SUNDRY NOTICES AND REPORTS ON WELLS

8. Well Name and No.
CORRAL FLY 35-26 FEDERAL COM 22H

OXY USA Inc. respectfully requests to amend the APD for the following wells. The five wells will have a similar design. The specific details (i.e. depths, cement volumes, etc) attached are for the 22H.

OXY USA Inc. - Corral Fly 35-26 Federal Com #22H, 23H, 24H, 25H, 26H – Amended Drilling Plan

13-5/8" 5M MN-DS Wellhead System

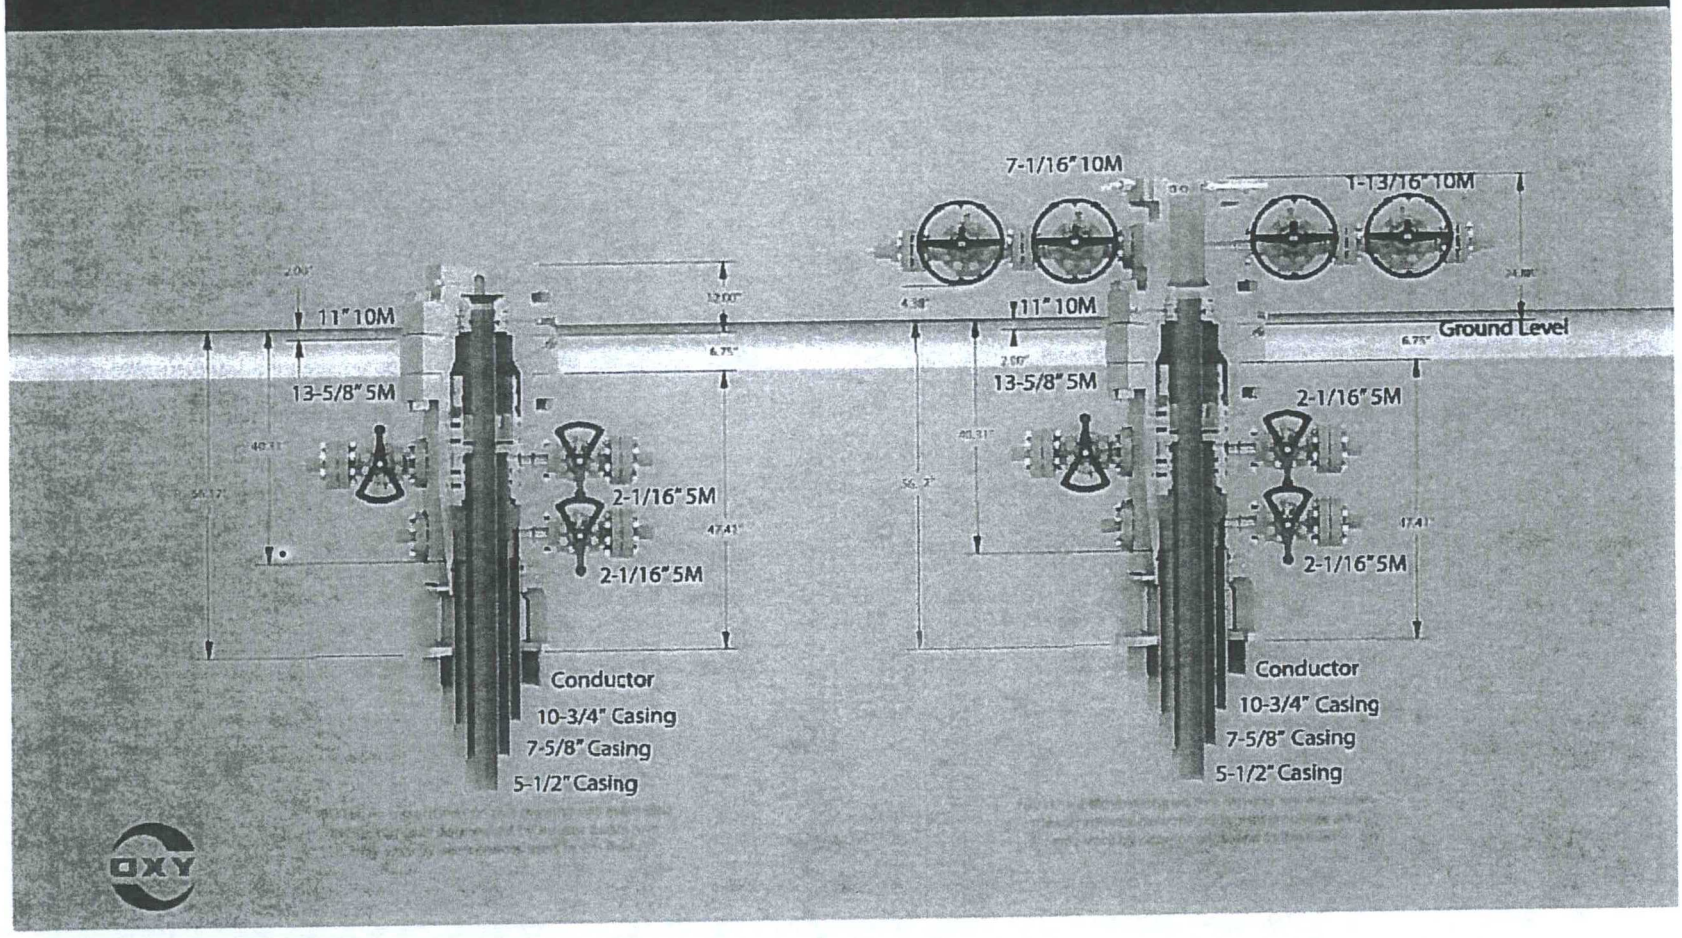
3. Amend the pressure control equipment due to casing size changes, see attached.

BOP installed and tested before drilling which hole?	Size	Min. Required WP	Type		Tested to:
9.875" Hole	13-5/8"	5M	Annular	x	70 % of working Pressure
			Blind Ram	x	250/5000 psi
			Pipe Ram		
			Double Ram	x	
			Other*

5M BOP Stack

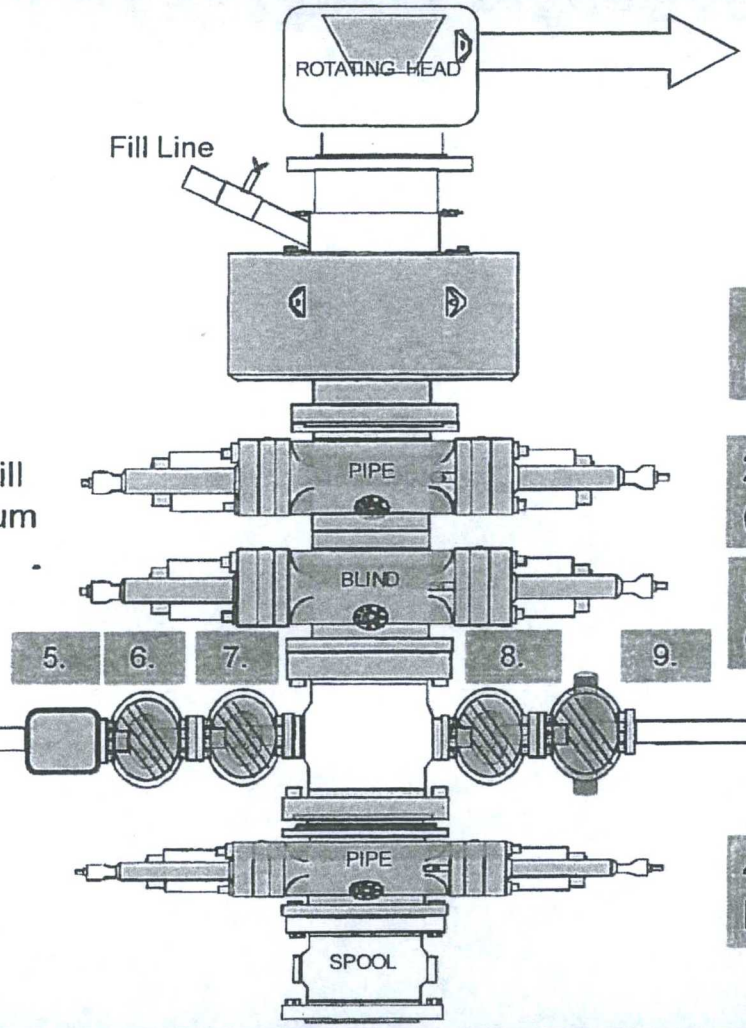
Pipe rams will be operationally checked each 24 hour period. Blind rams will be operationally checked on each trip out of the hole. These checks will be noted on the daily tour sheets. Other accessories to the BOP equipment will include a Kelly cock and floor safety valve (inside BOP) and choke lines and choke manifold. See attached schematics.
